Office Action Summary

10/089,041

GRIMM ET AL.

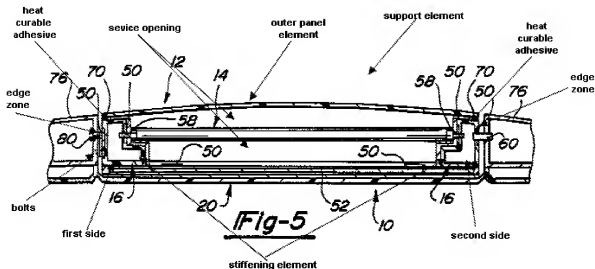
Claims 13-18, 20-30 and 34-35, 39-40 are rejected under 35 U.S.C. 102(b) as being anticipated by Ritchie (5,857,732). Ritchie (5,857,732) discloses a vehicle door module comprising a support element (see figure below), an outer panel element (12) to close the service opening along an edge zone, an elongated metal stiffening element (50), a spacing element (70) in the form of a heat curable adhesive (column 4, lines 34-67) which allows adjustability between the parts (i.e., the outer panel element and the elongated stiffening element) in two dimensions, which are to be fastened, and bolts (80) detachably joined to the stiffening element (50) and support element, an interior panel element (20), and a hinge (80).

The applicant's arguments have been considered but are not deemed persuasive. The applicant argues that the art of record, specifically Ritchie, does not disclose the spacing element contacting the stiffening element, the support element, and the outer panel element. As shown and discussed in detail above, the spacing element clearly contacts the outer panel element and the stiffening element. Furthermore, the applicant recites "the support element" which is read on Ritchie as being any and/or all parts of the "shell" of the door which forms the service opening in which almost all automobile doors have and therefore the spacing element would clearly be in contact with another other portion of the door that's not defined by the stiffening element and the outer panel element.
